6.2 Containment Systems

The information in this section of the reference ABWR DCD, including all subsections, tables, and figures, as modified by the STP Nuclear Operating Company Application to Amend the Design Certification rule for the U.S. Advanced Boiling Water Reactor (ABWR), "ABWR STP Aircraft Impact Assessment (AIA) Amendment Revision 3," dated September 23, 2010 is incorporated by reference with the following departures and supplements.

Figure 6.2-3 Feedwater Line Break Flow—Feedwater System Side of Break

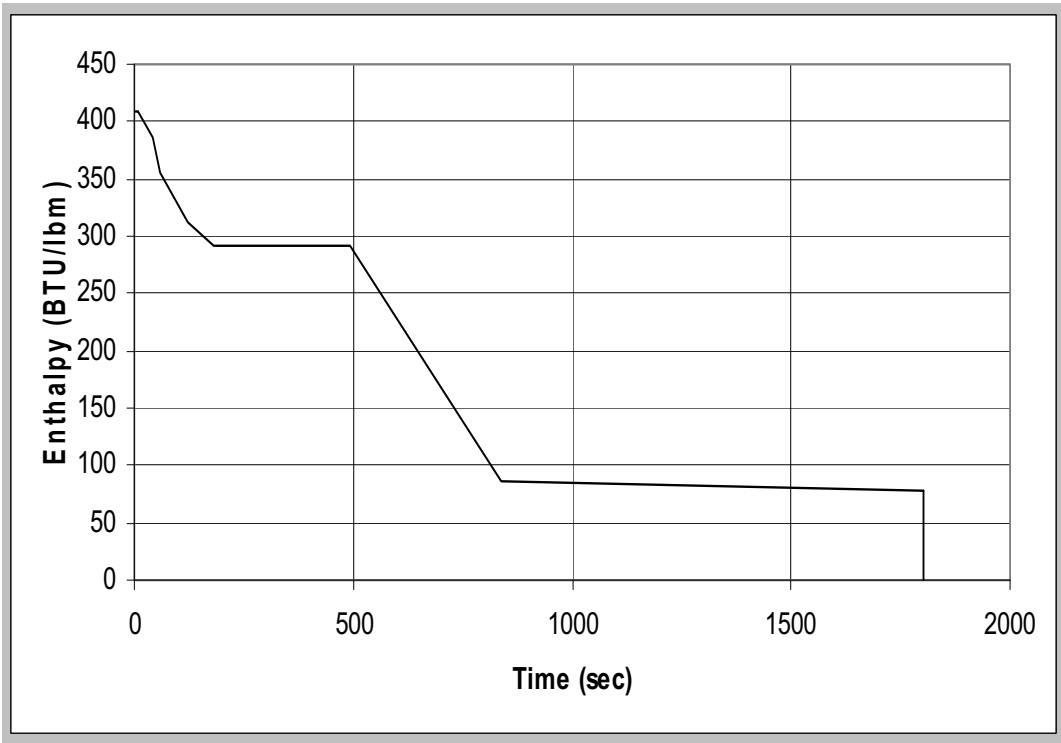
~~The maximum possible feedwater flow rate was calculated to be 164% of nuclear boiler rated (NBR), based on the response of the feedwater pumps to an instantaneous loss of discharge pressure. Since the Feedwater Control System will respond to decreasing RPV water level by demanding increased feedwater flow, and there is no FWLB sensor in the design, this maximum feedwater flow was conservatively assumed to continue for 120 seconds (Figure 6.2-3). This is very conservative because:~~

In order to provide further assurance of conservatism, FWLB mitigation is added to the ABWR design. The system is described in Section 7.3.1.1.2. The specific enthalpy time history, assuming the break flow of Figure 6.2-3, is shown in Figure 6.2-4. Initial reactor power is assumed to be 102% NBR.

Figure 6.2-6a Drywell Pressure Response for Feedwater Line Break

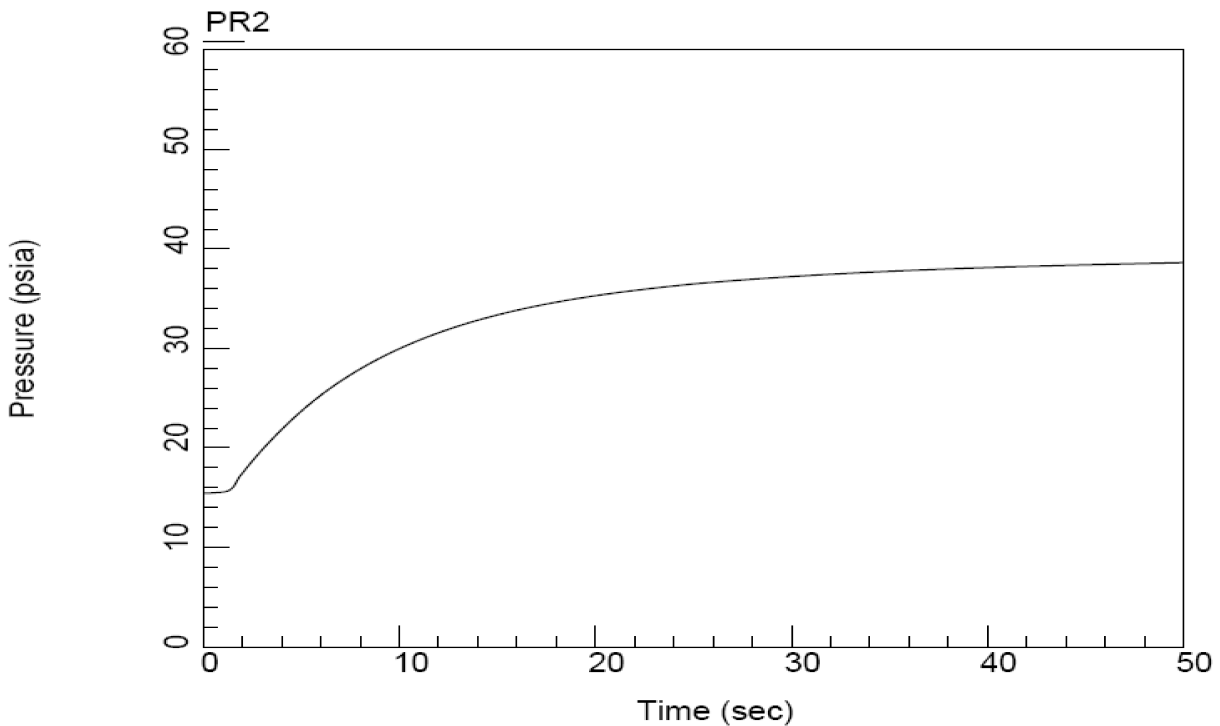
STD DEP 6.2-2 (Tables 6.2-1 and 6.2-2, Figures 6.2-2, 6.2-3, 6.2-4, 6.2-5, 6.2-6a and b, 6.2-7a and b, 6.2-8a, 6.2-8b, 6.2-8c, 6.2-9, 6.2-10, 6.2-11, 6.2-12a and 6.2-12b, 6.2-13a and 6.2-13b, 6.2-14, 6.2-15, 6.2-22, 6.2-23a, 6.2-23b, 6.2-24, 6.2-25a, and 6.2-25b.)

~~The calculated containment pressure and temperature responses for a feedwater line break are shown in Figures 6.2-6 and 6.2-7, respectively. The peak pressure (268.7 kPaG) and temperature (140°C) occur in the drywell. The containment design pressure of 309.9 kPaG is 115% of the peak pressure.~~

The maximum drywell pressure occurs in the case of a feedwater line break (~~268.7~~281.8 kPaG). The design pressure for the drywell (309.9 kPaG) includes 16%approximately 10% margin.

Figure 6.2-9 ABWR Main Steamlines with a Break

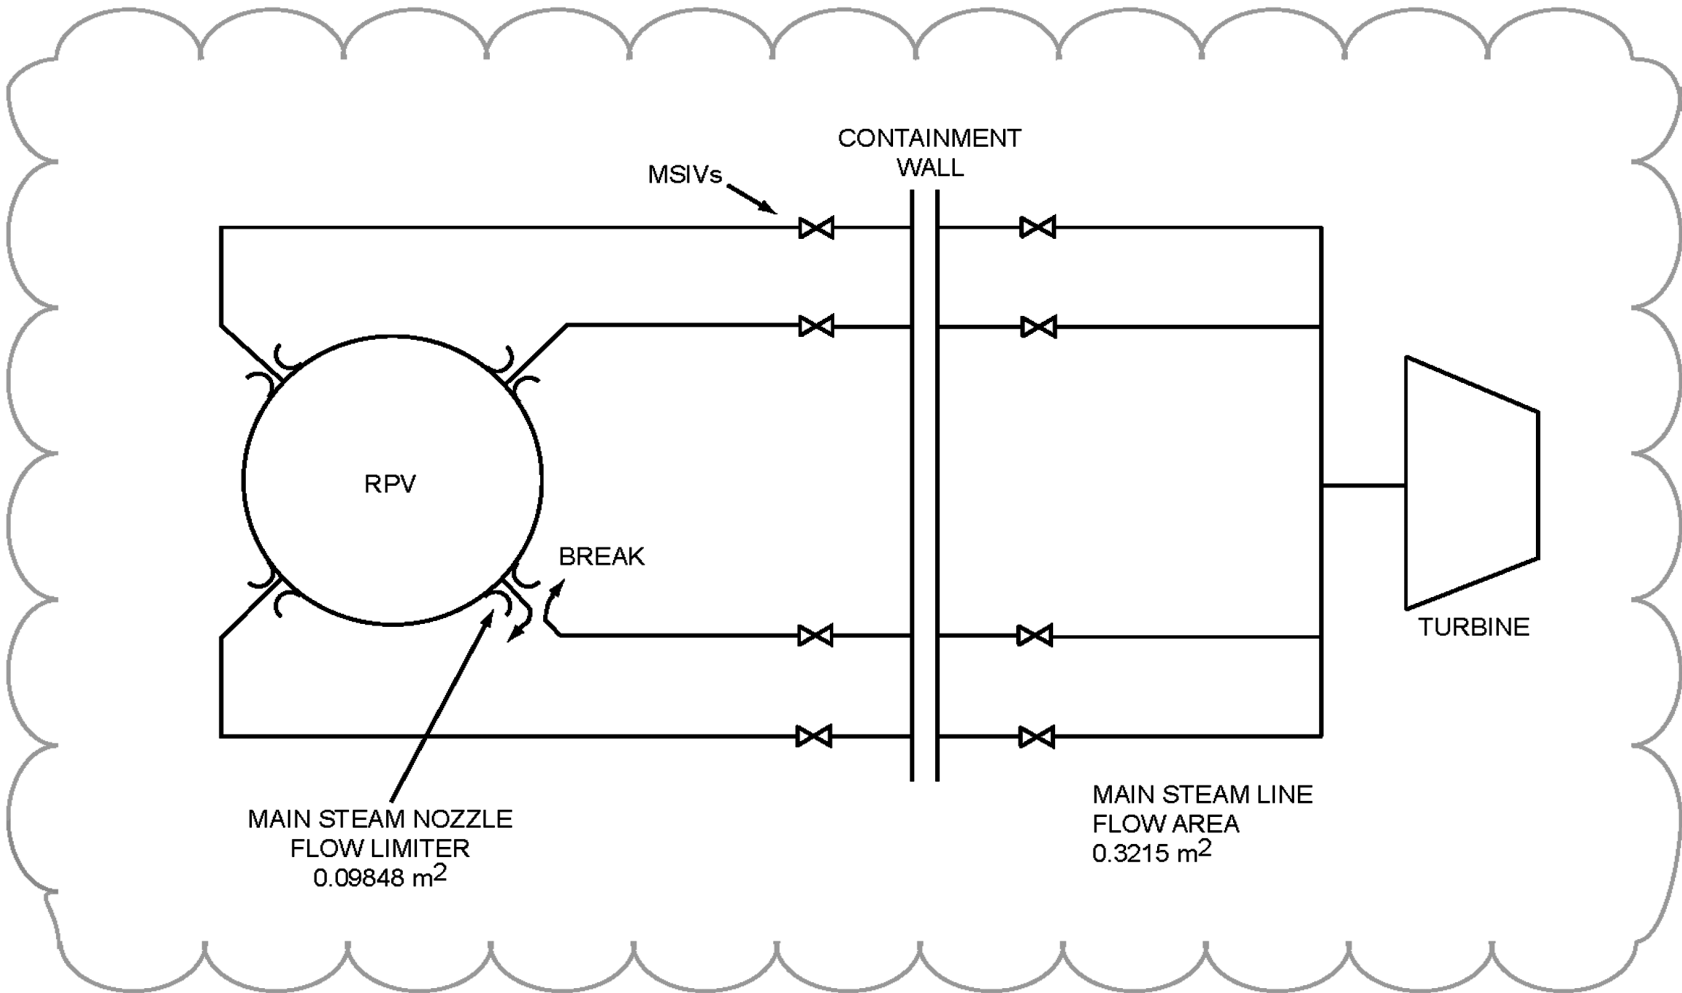
A schematic of the ABWR main steamlines, with a postulated break in one of the main steamlines, is shown in Figure 6.2-9. The main steamline (MSL) break is a double-ended break with one end fed by the RPV directly through the broken line, and the other fed by the RPV through the unbroken main steamlines until the MSIVs are closed. Once the MSIVs are closed, the break flow is only from the RPV through the broken line.

Each MSL contains a flow limiter built into the MSL nozzle on the RPV with a throat area of 0.09848 m², as shown in Figure 6.2-9. This flow limiter provides the effective break area for the vessel side.

- (1) Each MSL contains a flow limiter built into the MSL nozzle on the RPV with a throat area of 0.0983m², as shown in Figure 6.2-9.*
- (2) The break is located in one MSL at the inboard MSIV.*
- (3) During the inventory depletion period, the flow multiplier of 0.75 is applied (Reference 6.2-1).*
- (4) The flow resistance of open MSIVs is considered. A conservative value of 2.062 for pressure loss coefficient for two open MSIVs was taken. The nominal value is approximately 3.0. When the open MSIV resistance is considered, the flow chokes at the MSIV on the piping side as soon as the inventory depletion period ends. The effective flow area on the piping side reduces to 70% of a frictionless piping area. The value of 70% applies to flow of steam and twophase mixture with greater than 15% quality.*

Figure 6.2-12a Drywell Pressure Time History for MSLB

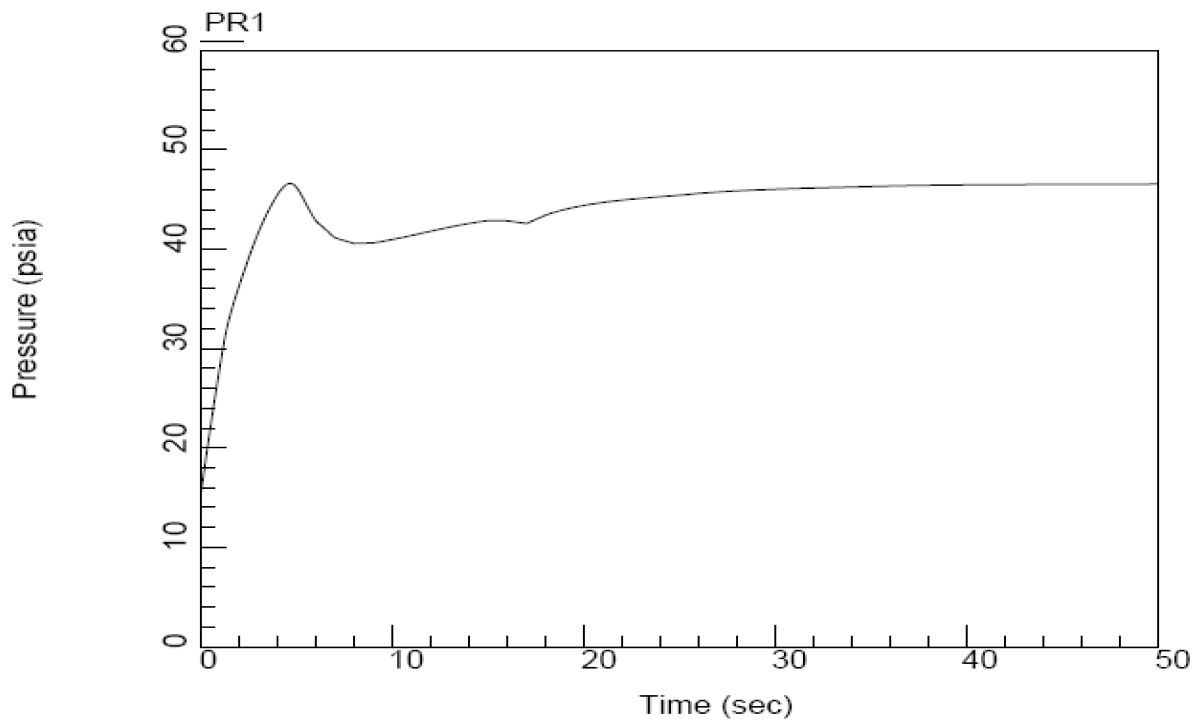
Figures 6.2-12 through 6.2-15 and 6.2-13 show the pressure and temperature responses of the drywell and wetwell during the blowdown phase of the steamline break accident.

Figure 6.2-13a Drywell Temperature Time History for MSLB

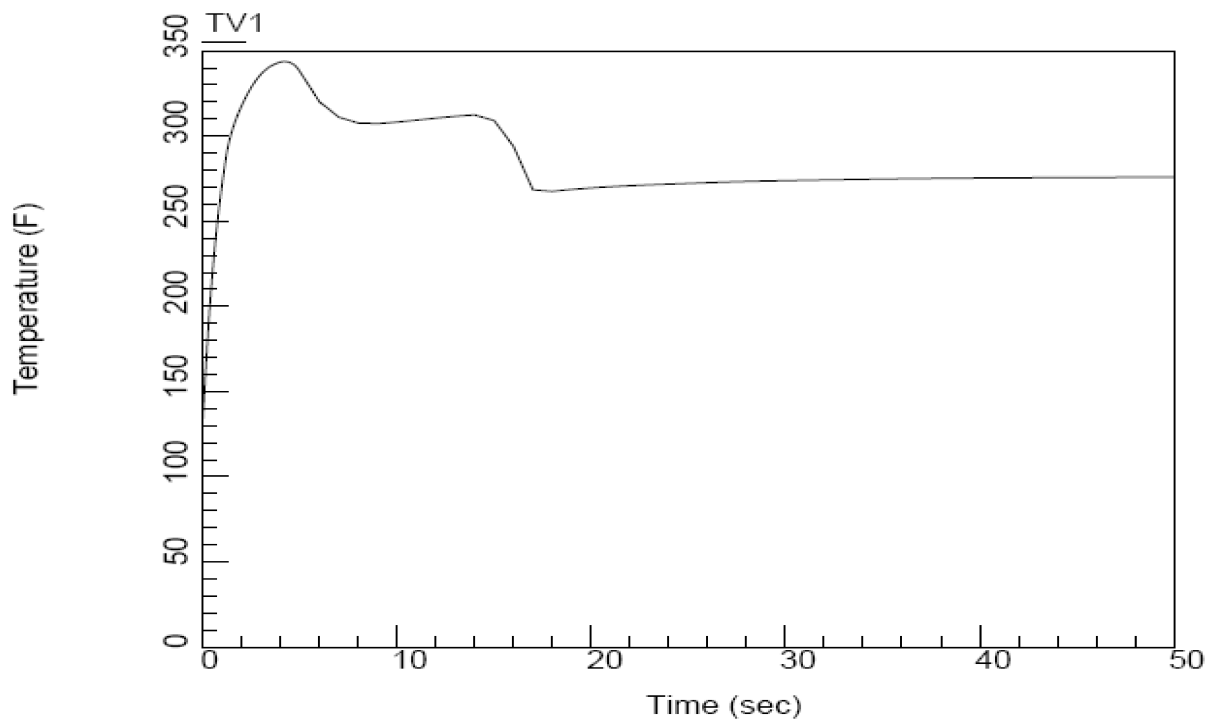
~~The long term containment pressure and temperature responses following the MSLB accident remain below those for the feedwater line break, which is the most limiting event.~~ The long-term containment pressure response following the MSLB accident remains below that for the feedwater line break. The long-term temperature response remains below that for the peak achieved in the short term for the steam line break shown in Figure 6.2-13.

The maximum drywell temperature (173.2°C) is predicted to occur for the steamline break. The MSLB with two-phase blowdown starting when the RPV collapsed water level is at or below the main steamline nozzle provides the highest peak drywell temperature. The peak drywell air temperature is 169.7/173.2°C, below the which is above the design value of 171.1°C, and is the limiting one as compared to the FWLB peak temperature. As noted in Section 6.2.1.1.2.1, this peak calculated drywell temperature exceeds the design limit for only 2 seconds. The peak drywell pressure for the MSLB remains below that for the FWLB, which becomes the most limiting. The peak drywell pressure is below the design pressure. The MSLB is the limiting event for peak drywell temperature. The FWLB is the most limiting for drywell pressure.
